GFA AIRWORTHINESS DIRECTIVE

- TYPE AFFECTED:** Pilatus B4-PC11, B4-PC11A and B4-PC11AF, all serial numbers.
- SUBJECT:** Inspection/replacement of control-column support on frame 2.

SERVICE BULLETIN NO: 1005

FUSELAGE - GENERAL CONTROL COLUMN SUPPORT ON FRAME 2 - INSPECTION

Support Frame 2 - Inspection
Figure 1

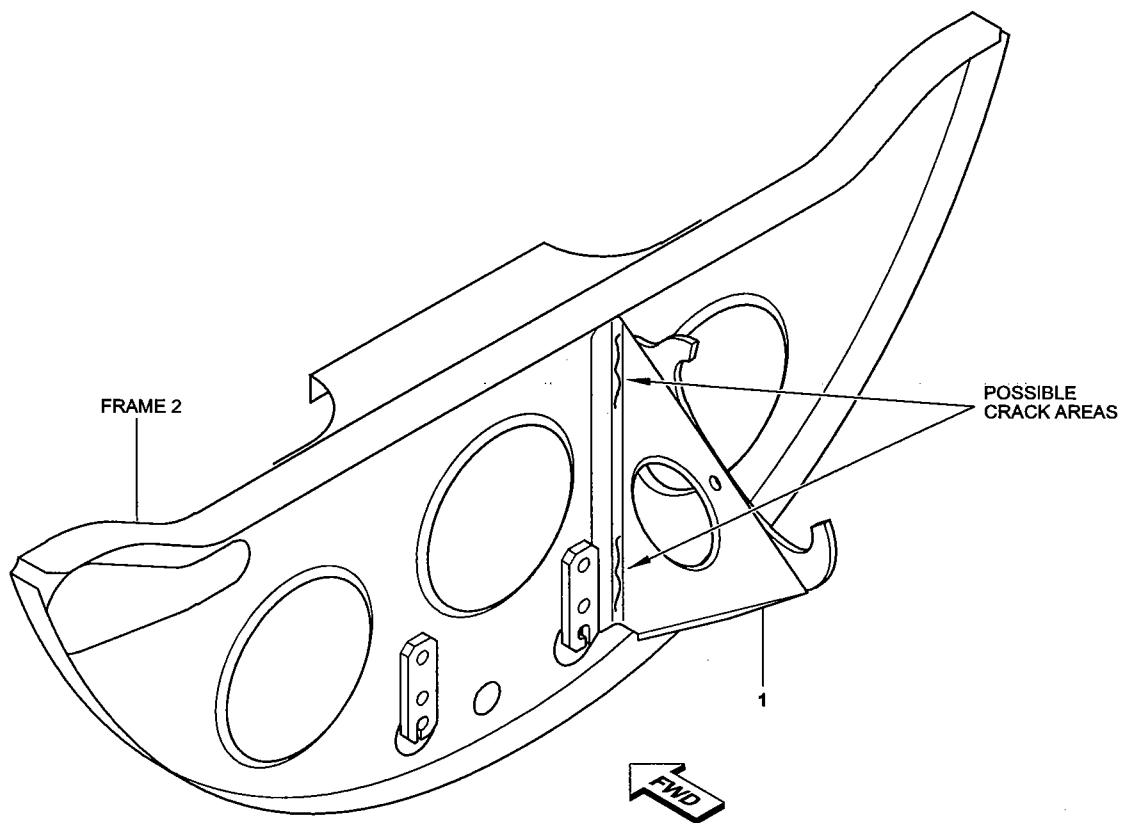
B. Inspection of the Support (Ref. Fig. 1)

- (1) Use a source of bright light and X10 magnifier and examine support (1) for cracks. Do this specially in the areas of the upper and lower bend angles where the support (1) is attached to Frame 2.
- (2) Cracks are not permitted in the support (1). Replace the support (1) if you find cracks.
- (3) Do the inspection again at each annual servicing.
